ADDENDUM NO. 1

Chubbuck Police H.Q. & Animal Shelter
5160 Yellowstone Avenue
Chubbuck, ID 83202

Pre-Bid Request for Information

FUB ASSEMBLY DETAIL

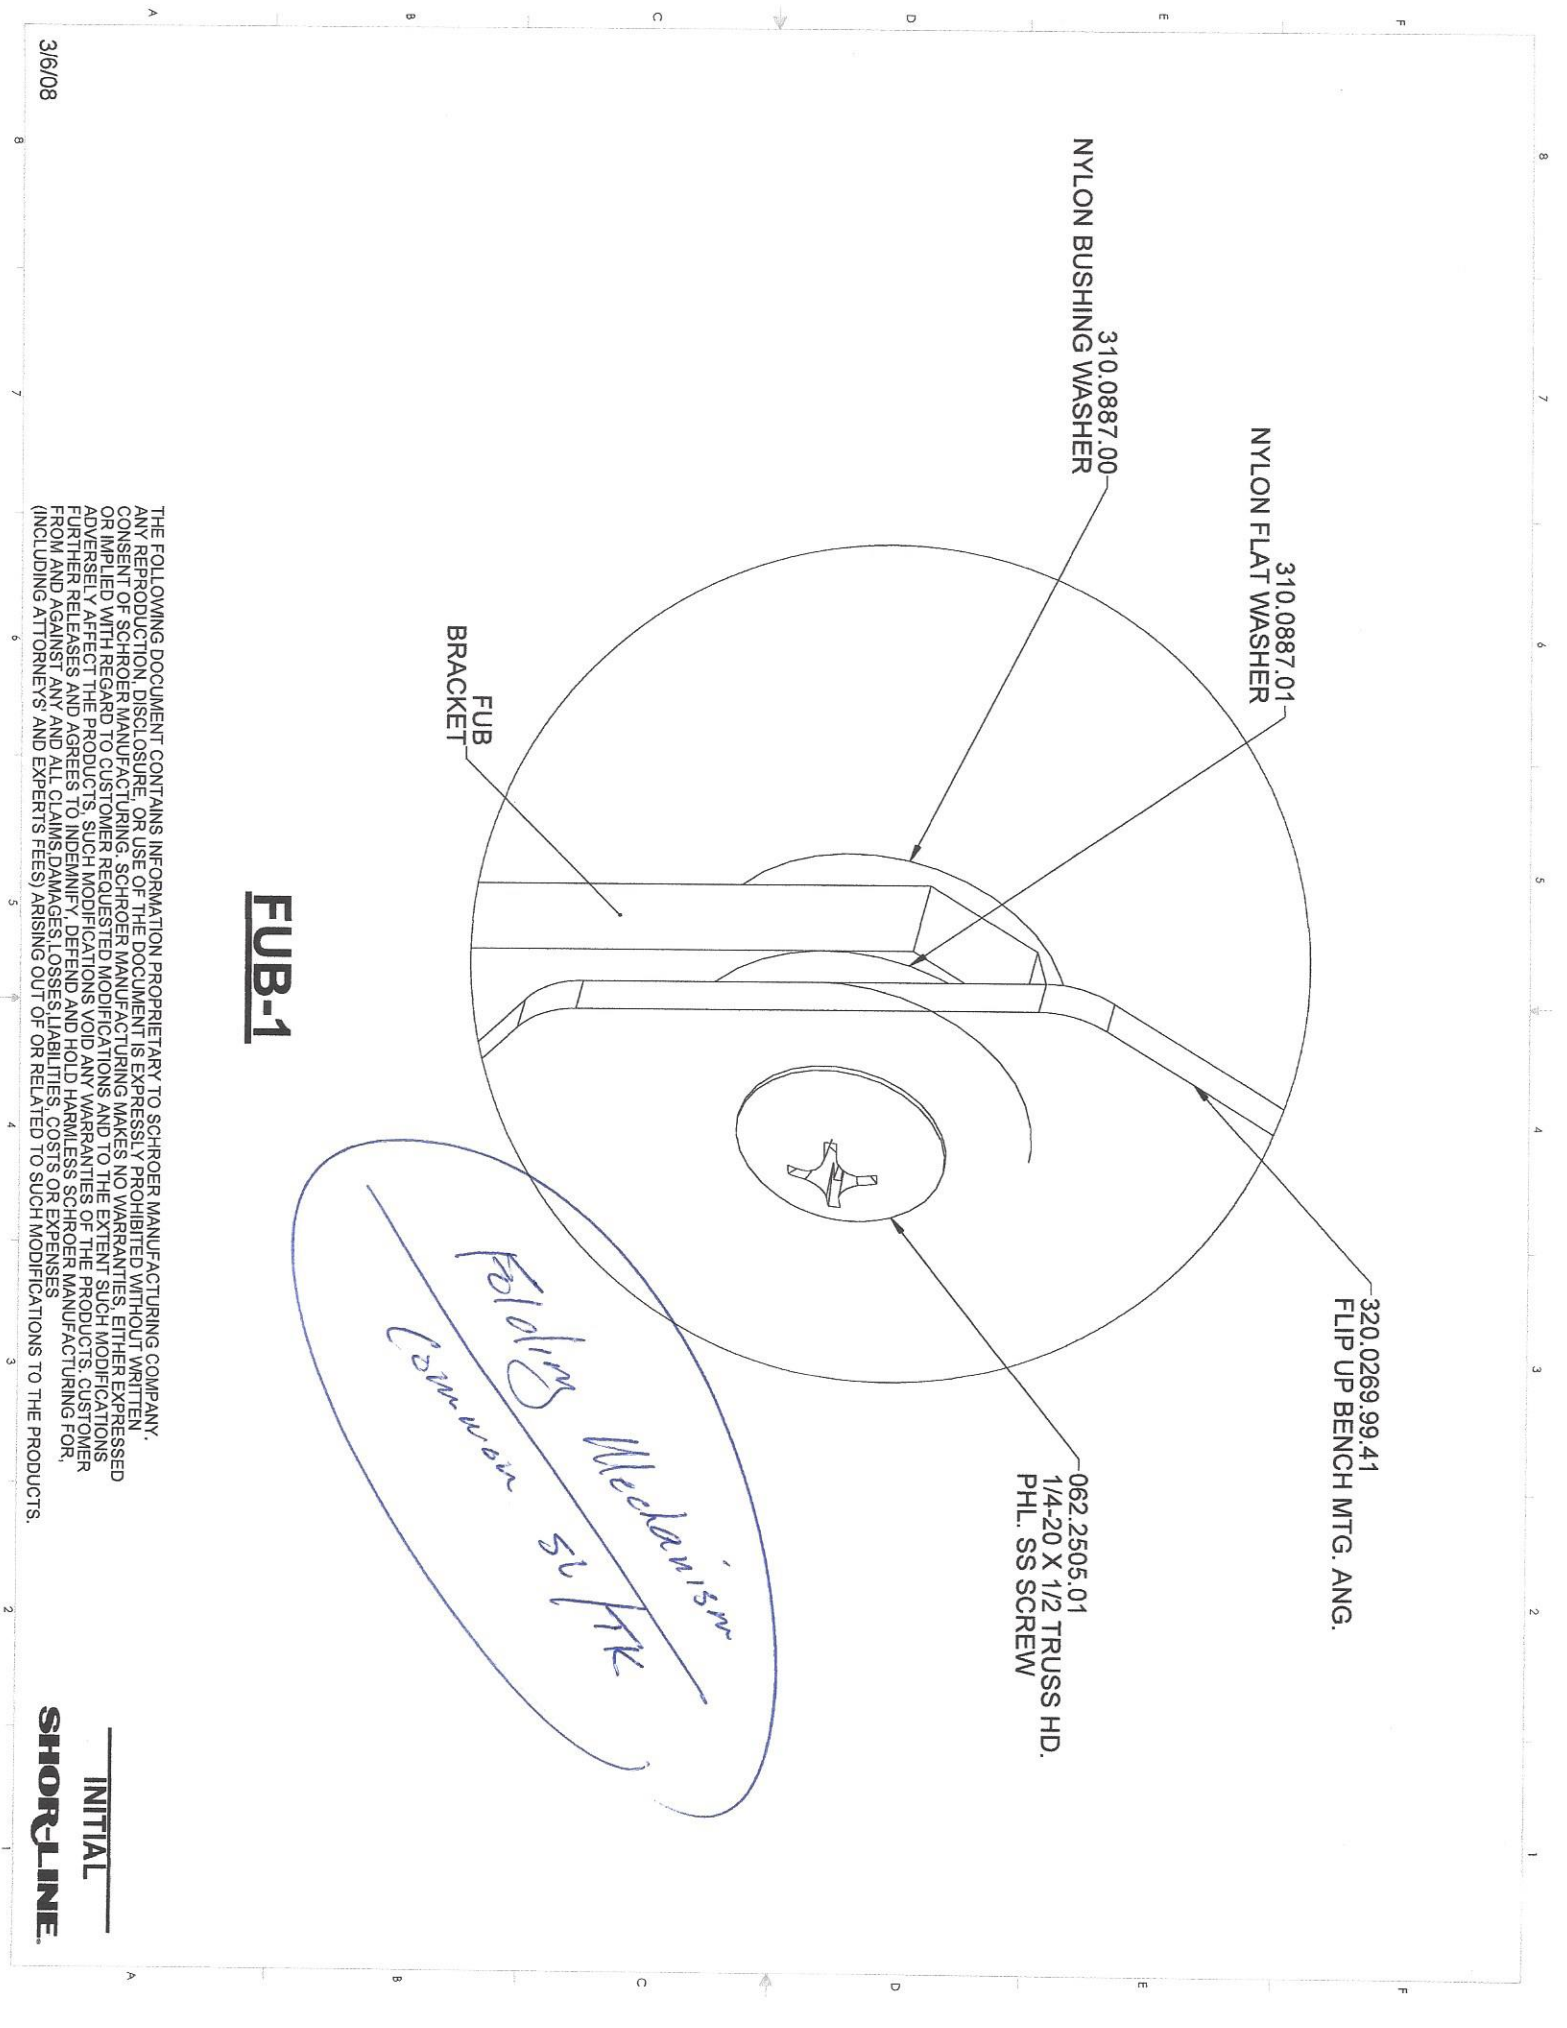
Accessories described are [competitor] Mason Co Resting skelton.
Shor-Line Does Not use Aluminum/FRP in any of our
components due to quality and service life issues.

Shor-Line is "Basis of design" for these level components.
Our Fold-up Benches are made of Stainless Steel and Dipped
PVC Steel Beds. See descriptors attached.
Shor-Line and Mason components do not combine.

No resting benches are required. Paragraph 2.3 can be disregarded.

ANATOMY OF A SHOR-LINE RUN SYSTEM

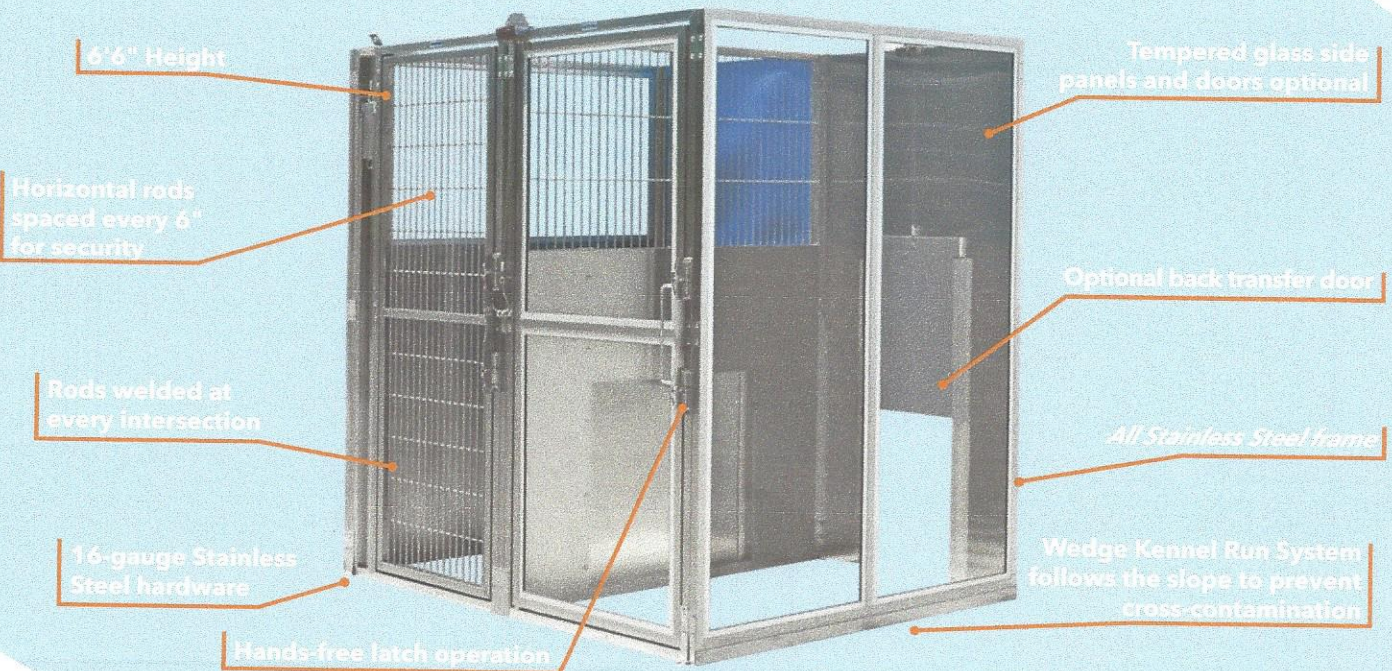
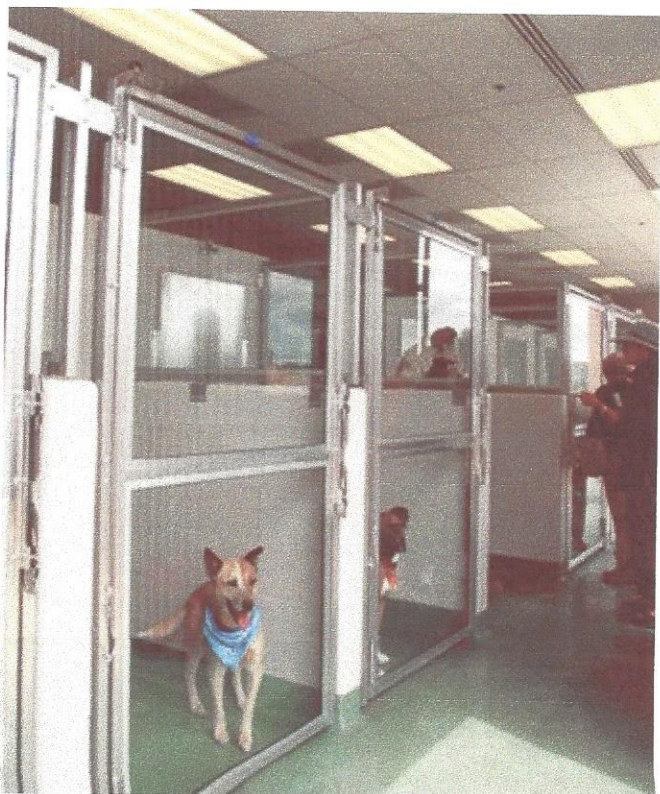
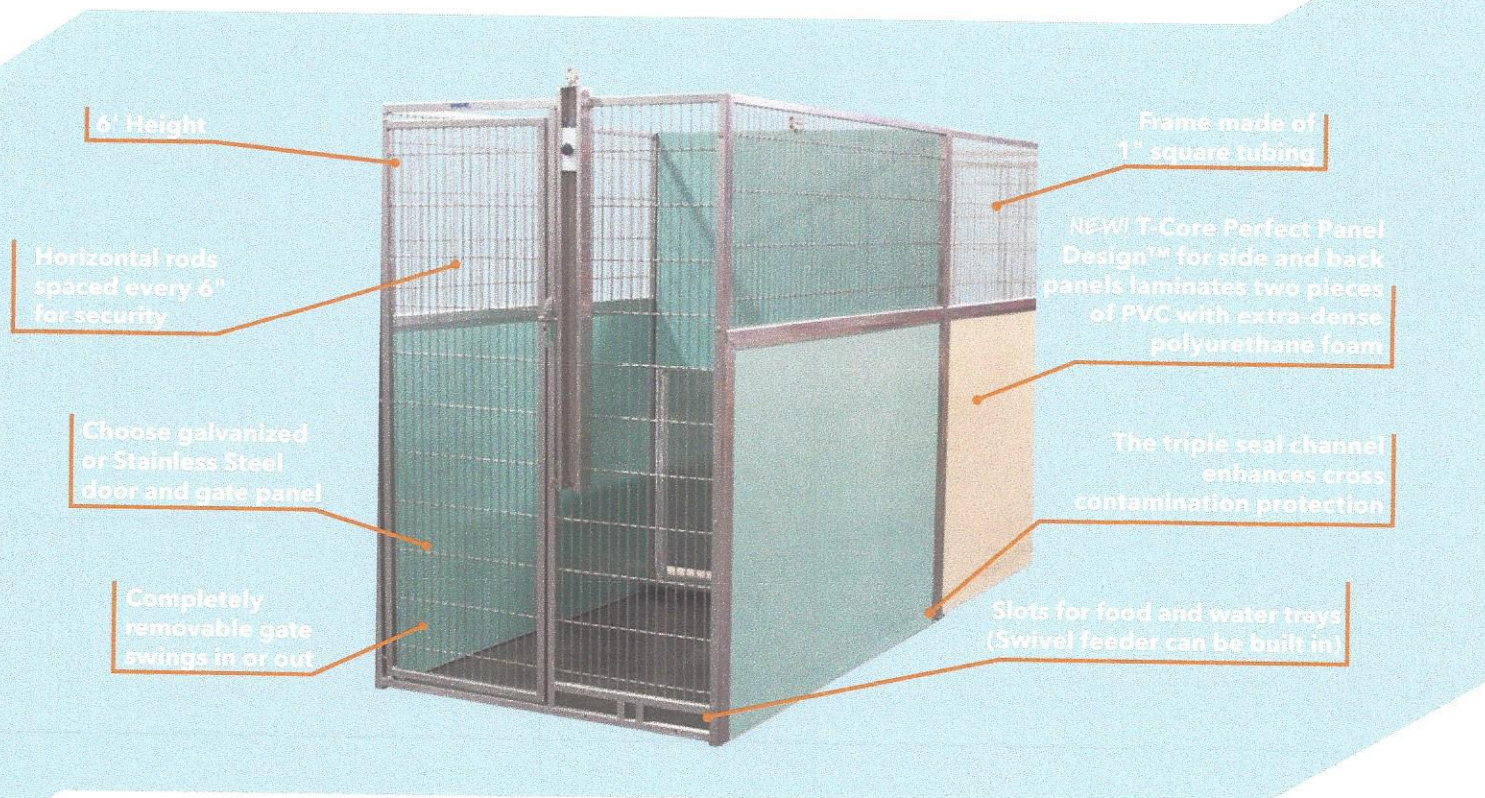
Request: Clarification:
 Section A - Kennel Fronts define Shor-Line (Brand) components
 i.e.: 1 1/4" tubing / 78" Height
 Whereas Section B defines T-Kennel (Brand) component -
 i.e.: 1" Tubing / 72" Height.

Both components made by Shor-Line BUT do no
 Comingle
 See attached descriptor pages - Choose proper component
 group

The Shor-Line component group is intended as the basis of design, as indicated by reference to 1 1/4" tubing and 78" height in Section 2.2.A

The reference to 1" tubing in Section 2.2.D should be corrected to 1 1/4" to be consistent with the other paragraphs.
